**PROPOSED TEMPORARY OPEN STORAGE OF  
CONSTRUCTION MATERIALS  
FOR A PERIOD OF 3 YEARS  
LOT 137(PART) IN DD128, HA TSUEN, YUEN LONG**

**PROPOSED TEMPORARY OPEN STORAGE OF CONSTRUCTION MATERIALS  
LOT 137(PART) IN DD128, HA TSUEN, YUEN LONG  
REVISED DRAINAGE IMPACT ASSESSMENT AND PROPOSAL**

**3.0 RESPONSE TO COMMENTS** (i-viii to corresponds to DSD's comments of 28/07/2023)

**D-02 A**  
DRAINAGE PLAN  
FLOW PATTERN OF  
ADJACENT LANDS  
1:1,000

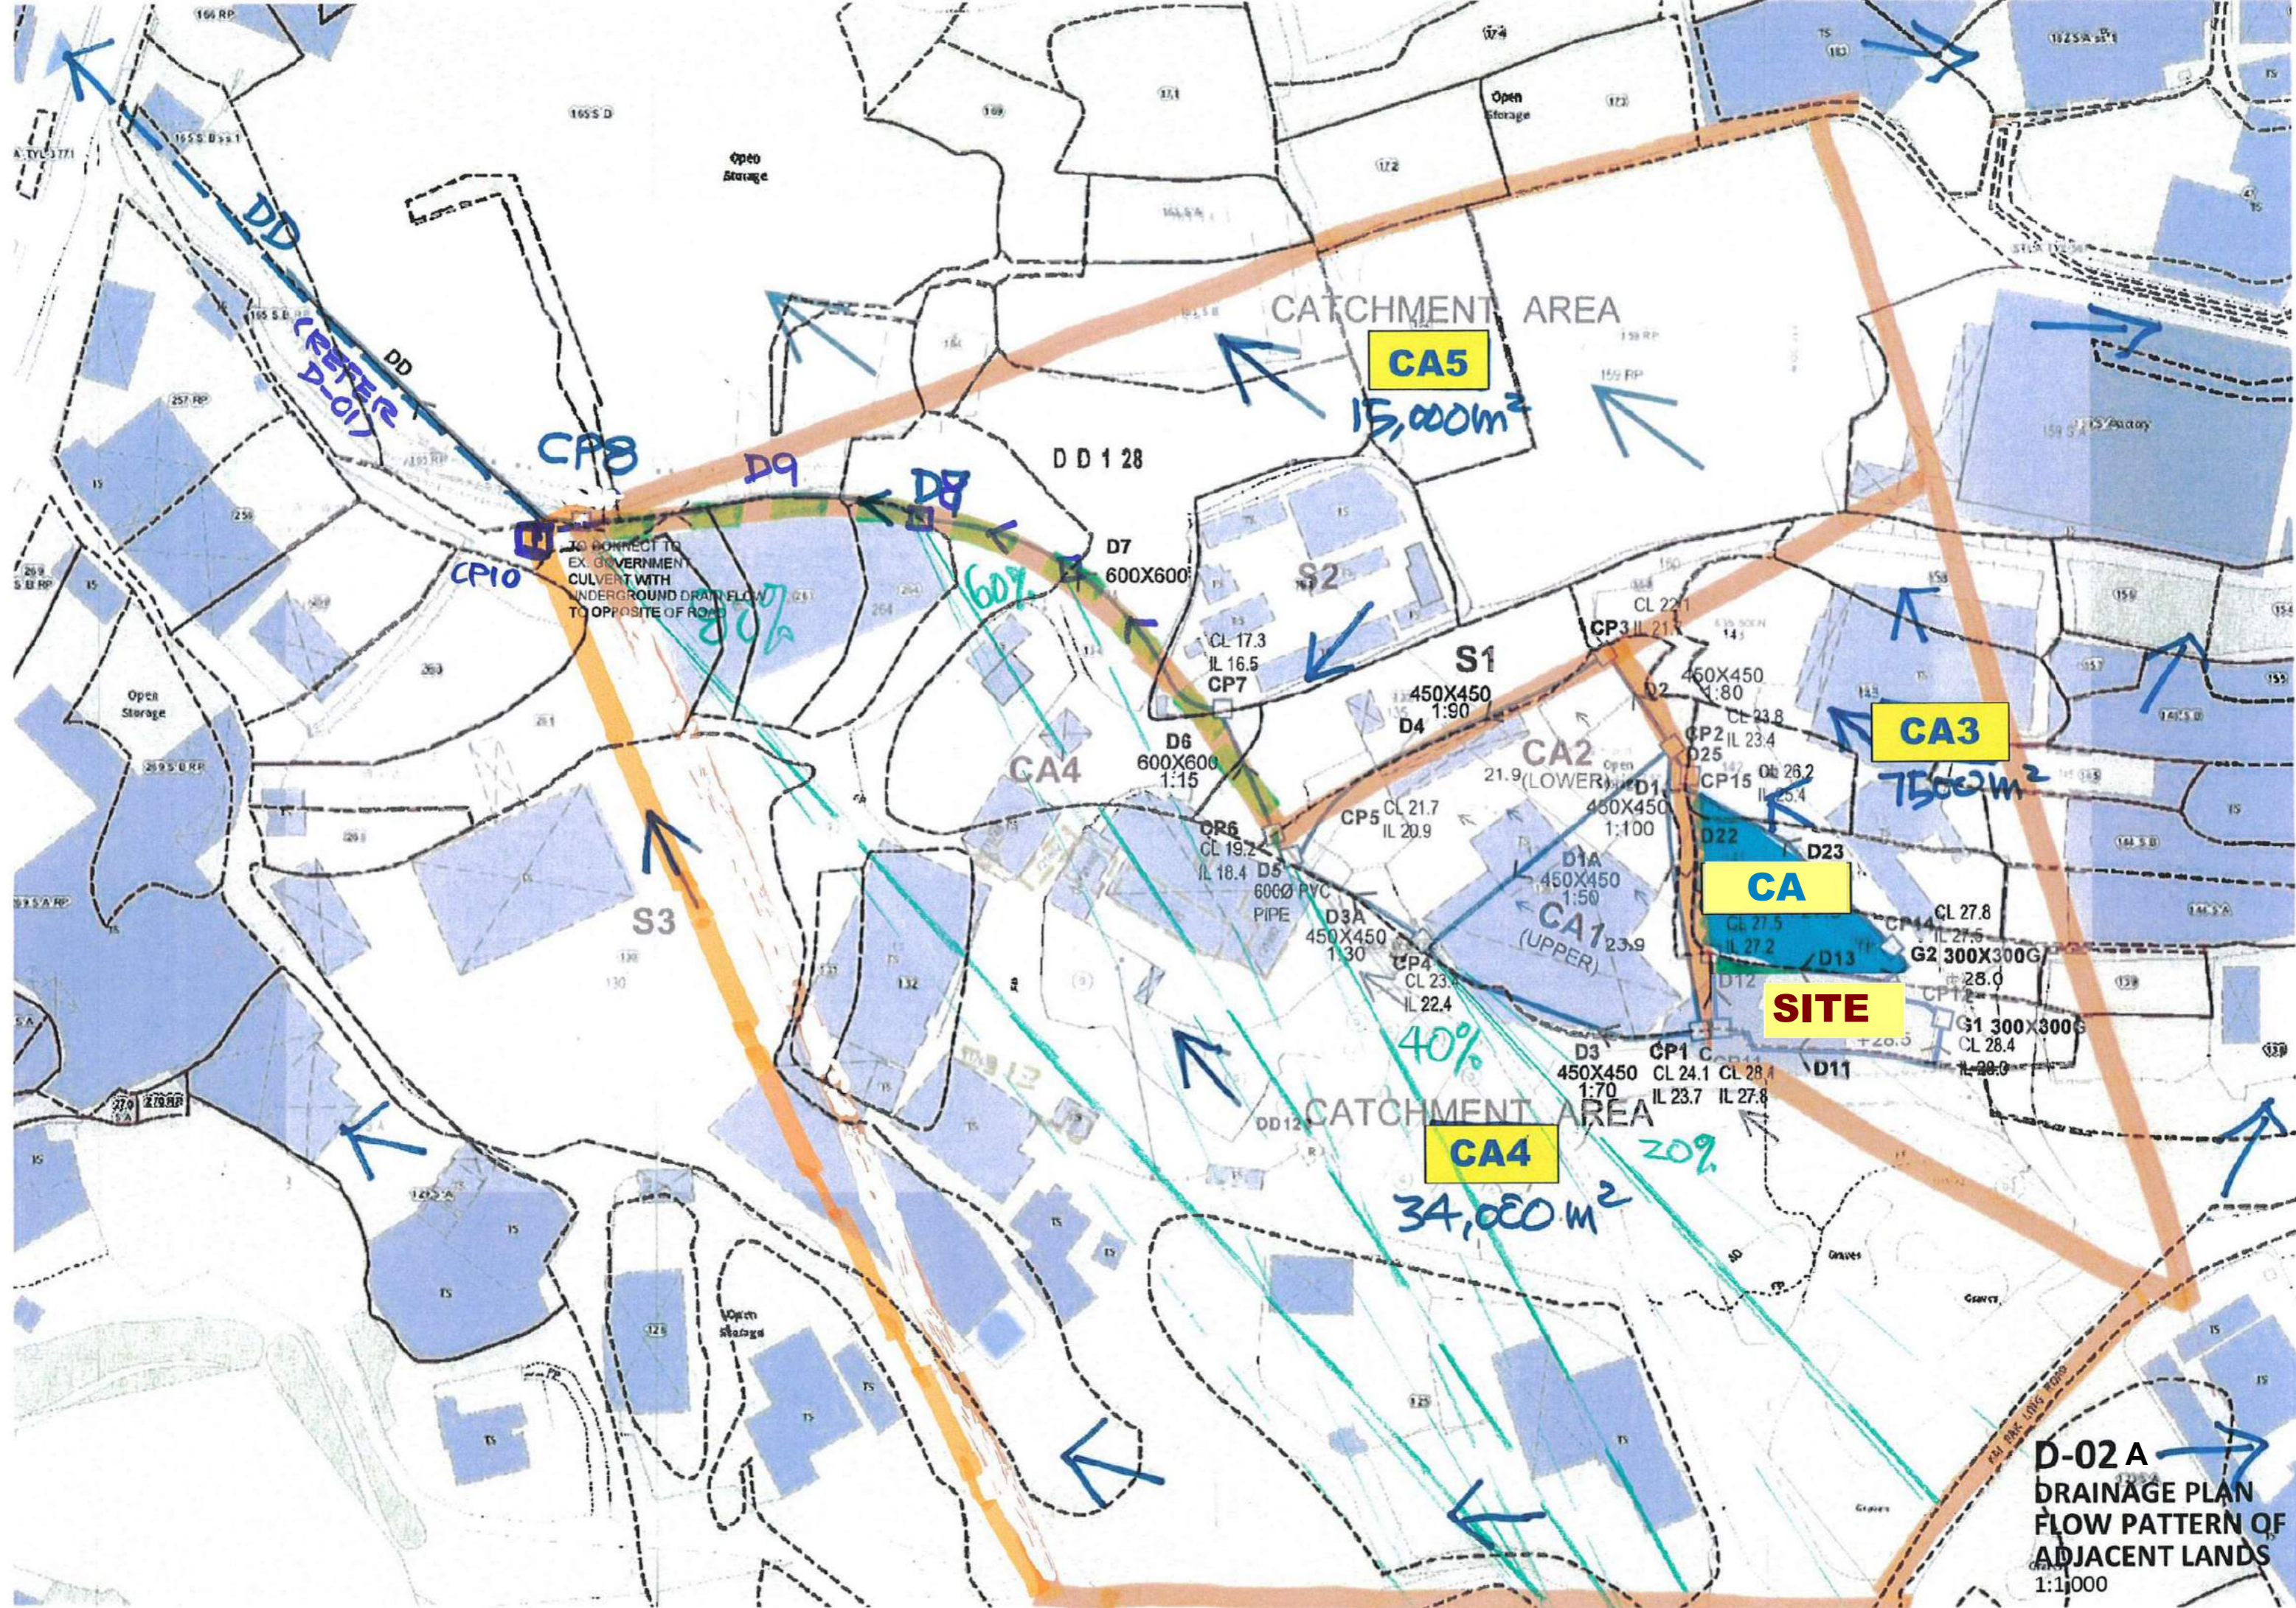
- i. **Drawing D-01 (rev J1)** – Proposed U Channels **D13 and D13A** will separately serve **Application Site** and **lower Site CA** (A/YL-HTF-1119) ; and will be collected at catchpit CP13 (shared by both sites).
- ii. Most runoff from CA4 is to be handled by D11, D3, D3A, D6, D7, D8 and D9; the percentage is for arithmetical / geometric share (refer D-02 Flow Pattern Plan) of runoff to these channels, and each of these channels are having spare capacity to handle spare percentage runoff by calculation.
- iii. Please refer to **Revised Hydraulic Calculation** for each channel.
- iv. The Application Site is formed higher than the road serving the Site, and Site is designed to fall away from G1; accordingly G1, will only have minimal runoff to handle.

**DRAINAGE PROPOSAL - HYDRAULIC CALCULATION**  
**LOT 137 (PART) OF DD128, HA TSUEN, YUEN LONG (v23.09)**

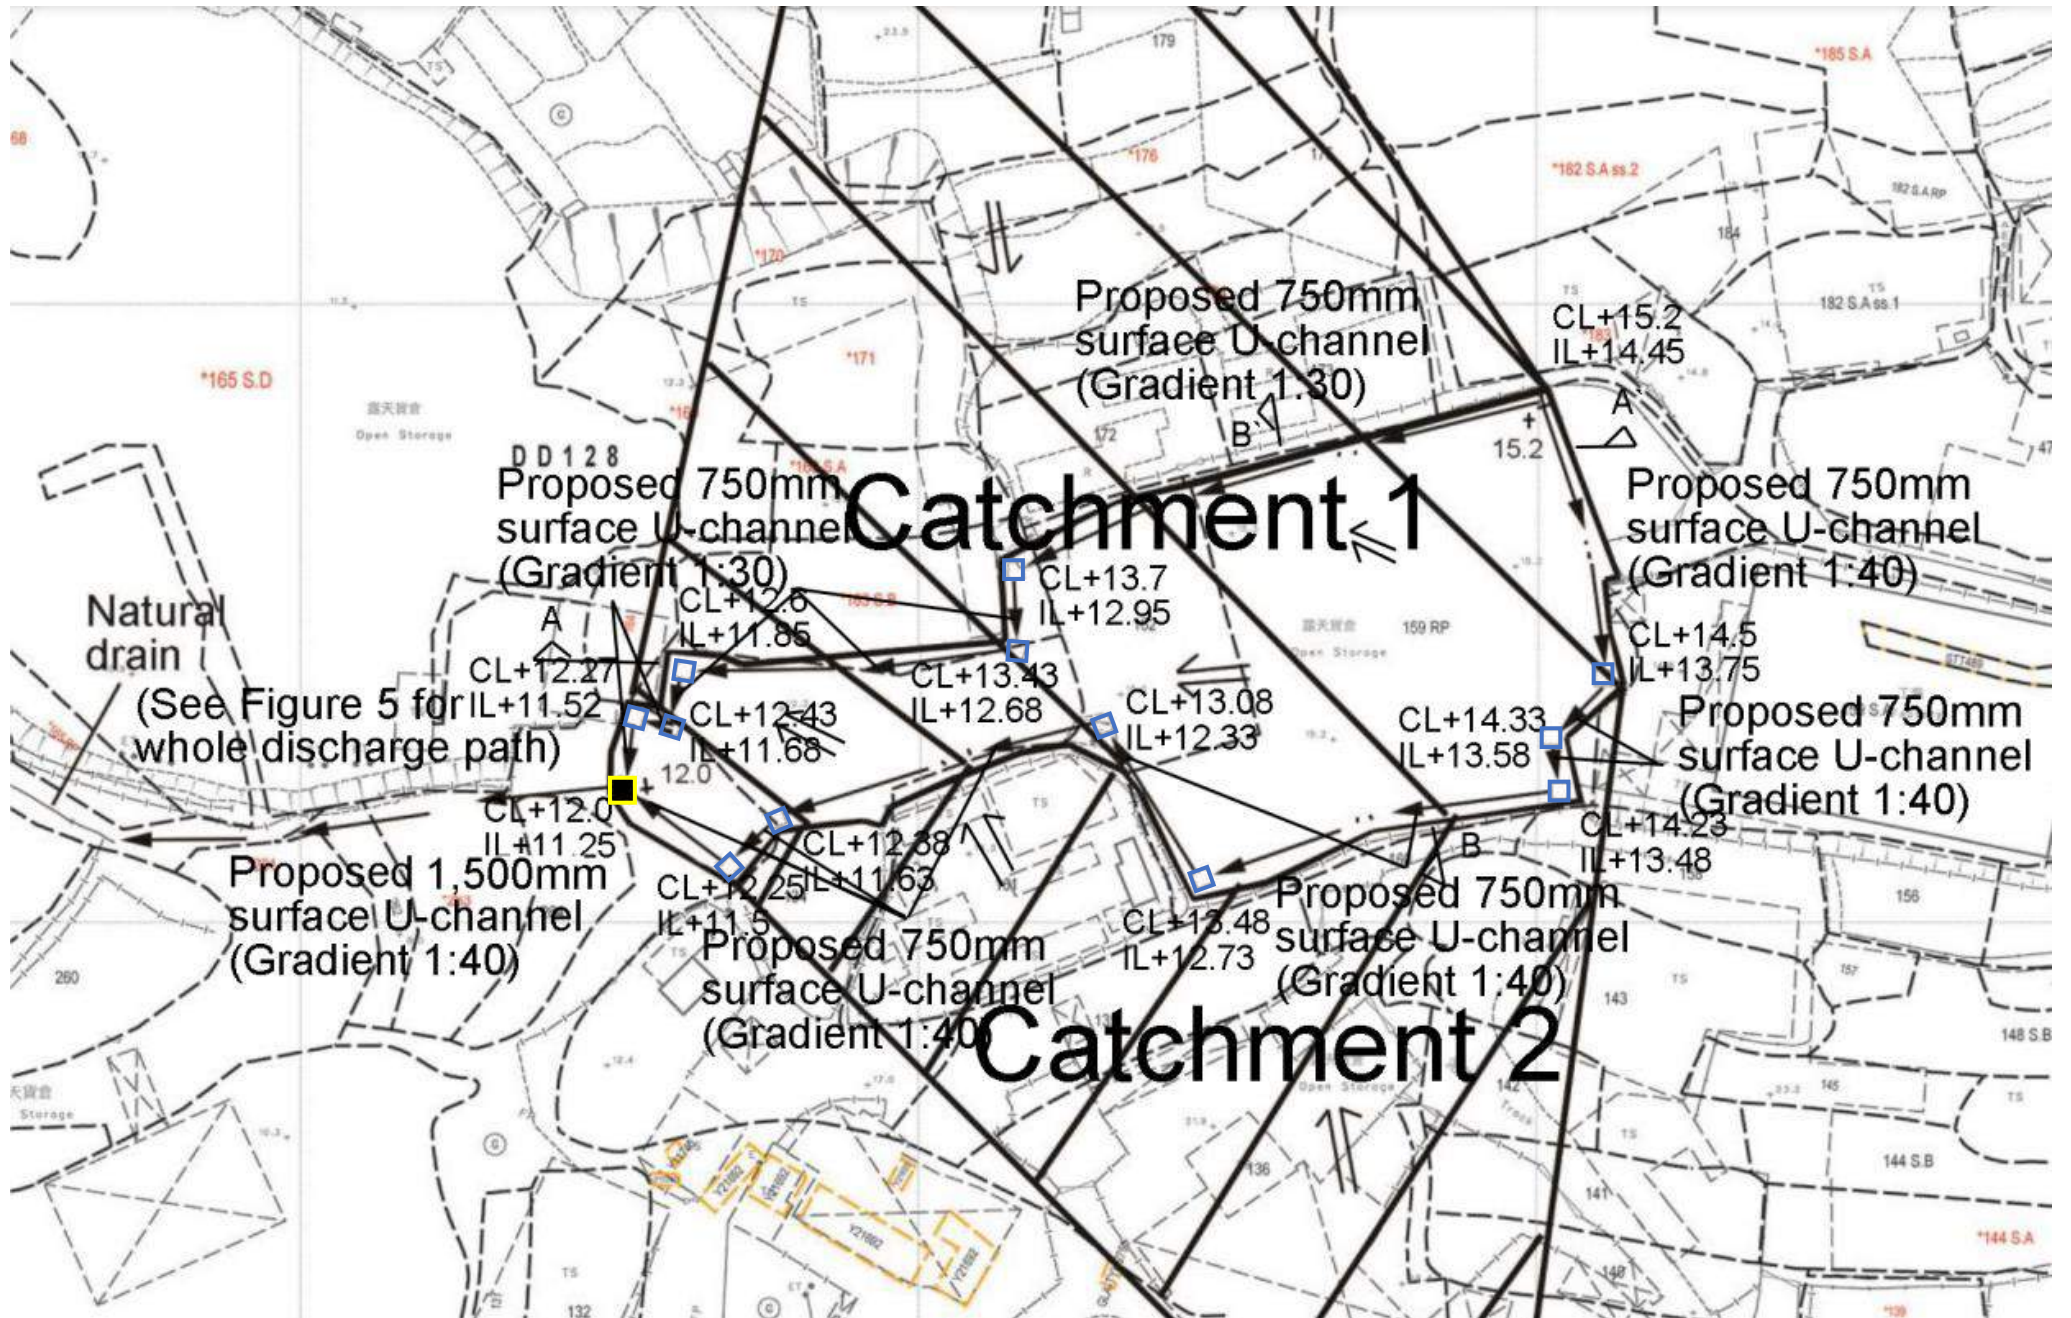
- v. discrepancy between plan and calculation were updated;
- vi. DD - photo has demonstrated it's presence; please also note that the CP10 has been updated on Plan to tally with existing site condition (refer to photo below);
- vii. refer photo below, and path from D6 to D9, and CP10 – DD, all to be constructed;
- viii. CP10 is the last manhole before discharging to DD (the underground pipe).

- APPLICATION SITE (THIS APPLICATION), 400X400MM IS ADEQUATE TO HANDLE SITE RUNOFF; SITE IS LEVELLED HIGHER THAN ADJACENT ROAD, AND 20% RUNOFF FROM UPSTREAM (CA4)
- NEIGHBOUR (LOWER) SITE CA, D22 400X400MM IS ADEQUATE TO HANDLE RUNOFF FROM APPLICATION SITE, and 10% OF CA4
- NEIGHBOUR SITE (CA1+CA2), D2, D4 IS ADEQUATE TO HANDLE RUNOFF FROM BOTH APPLICATION SITE, AND SITE CA
- CATCHMENT CA4 INCLUDES ALL DOWNSTREAM FACILITIES FOR APPLICATION SITE AND SITE CA, D7, D8, D9 CAN HANDLE ACCUMULATED CAPACITY OF UP TO 60% RUNOFF OF CA3, 70% OF CA4 AND 90% FROM CA5
- CAPACITY OF EXISTING PUBLIC U/G CHANNEL DD OF 0.9M DIAMETER, IS ADEQUATE TO HANDLE ACCUMULATED RUNOFF OF D9
